Subject: Waterford 3 SES
Docket No. 50-382
License No. NPF-38
Technical Specification Change Request NPF-38-230
Revision of RCS Cooldown Requirement

TECHNICAL SPECIFICATION CHANGE REQUEST
REVISION OF RCS COOLDOWN REQUIREMENT

WESTINGHOUSE REPORT ER-WS-PS-0001, REV 000
IMPROVEMENT OF TECHNICAL SPECIFICATION RCS COOLDOWN LIMITATIONS

FIGURE 3.4-3

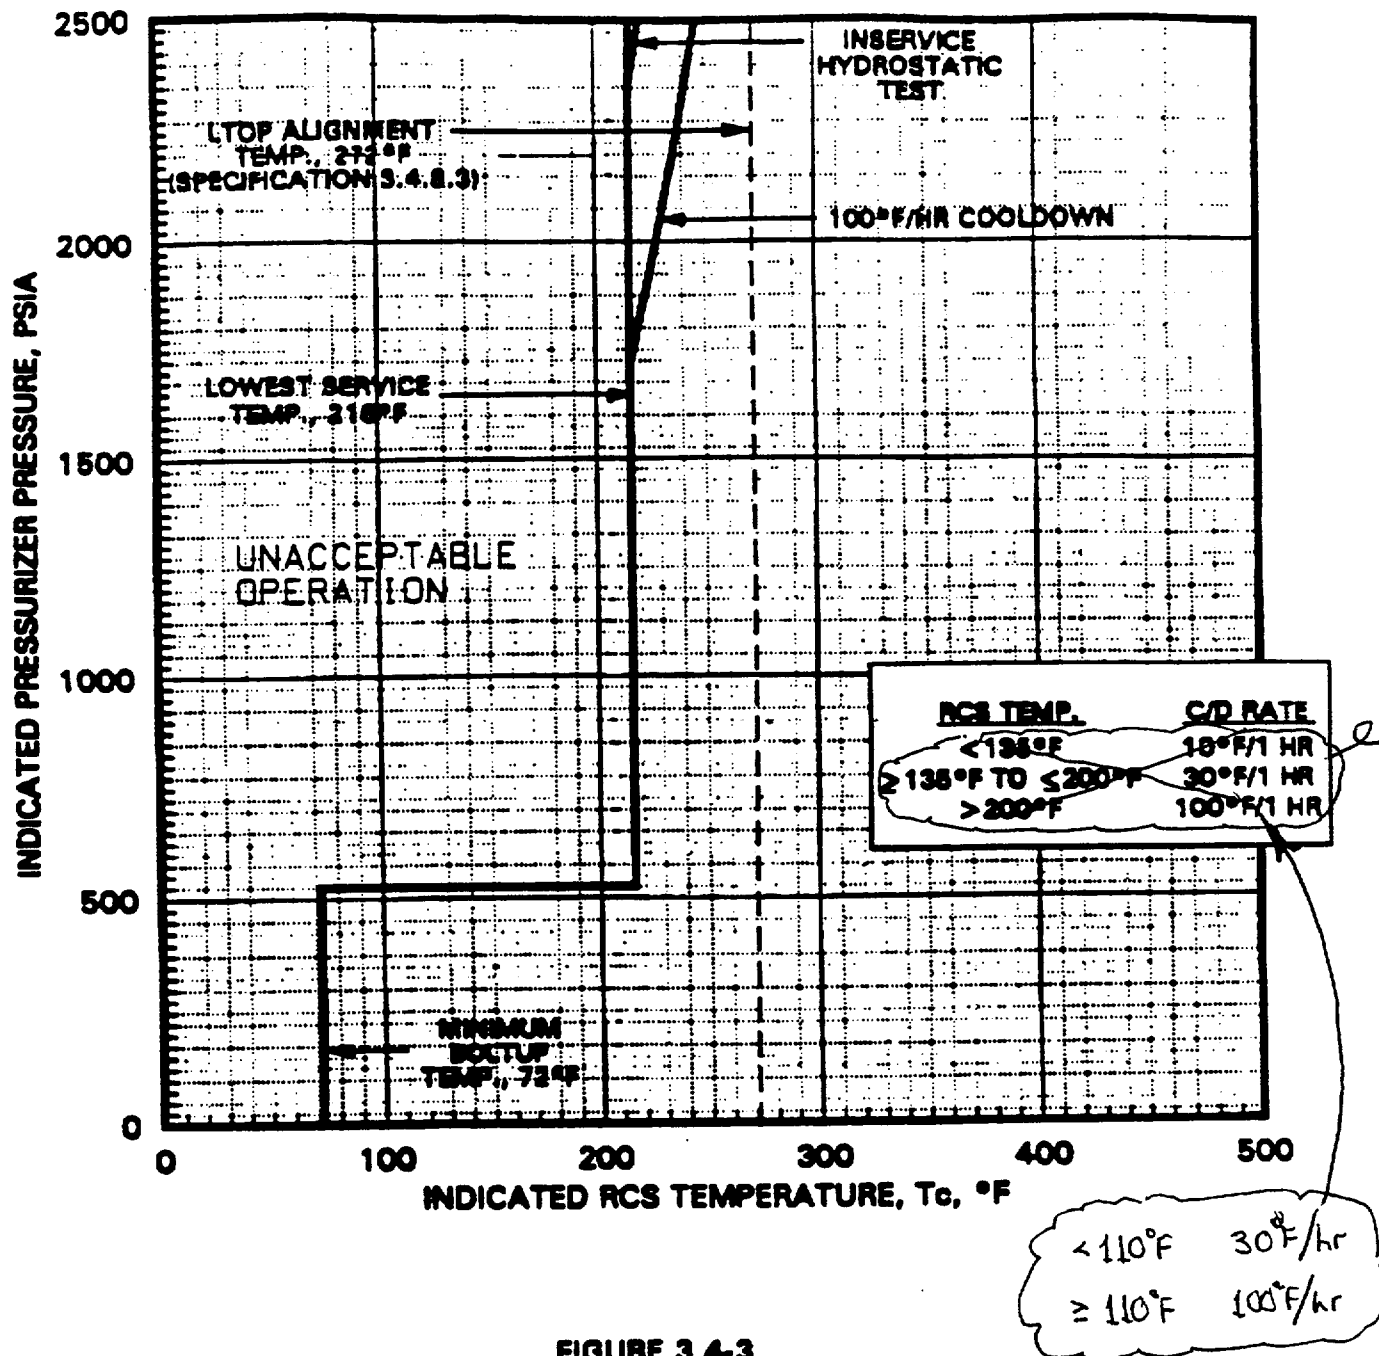
Waterford 3 proposes to amend its Operating License by modifying the Limiting Condition for Operation for Technical Specification (TS) 3.4.8.1 and Figure 3.4-3. The requested changes will revise the Reactor Coolant System (RCS) cooldown limitations to eliminate the 10°F per hour restriction at RCS temperatures below 135°F. The new cooldown rate steps are proposed as 100°F per hour at RCS temperatures down to and including 110°F and 30°F per hour limit at RCS temperatures below 110°F.

- Eliminate the 10 °F per hour cooldown limit currently at RCS temperatures below 135 °F.
- Extend the 100 °F per hour cooldown limit to be acceptable at RCS temperatures of 110 °F or greater.
- Establish a 30 °F per hour cooldown limit to be applicable at RCS temperatures below 110 °F.

- d g. A maximum cooldown rate of 30°F per hour with Reactor Coolant System cold leg temperature greater than or equal to 135°F and less than or equal to 200°F. 110°F

- e f. A maximum cooldown rate of 100°F per hour with Reactor Coolant System cold leg temperature greater than 200°F. or equal to 110°F
- f g. A maximum temperature change of less than or equal to 10°F in any 1-hour period during inservice hydrostatic and leak testing operations above the heatup and cooldown limit curves.
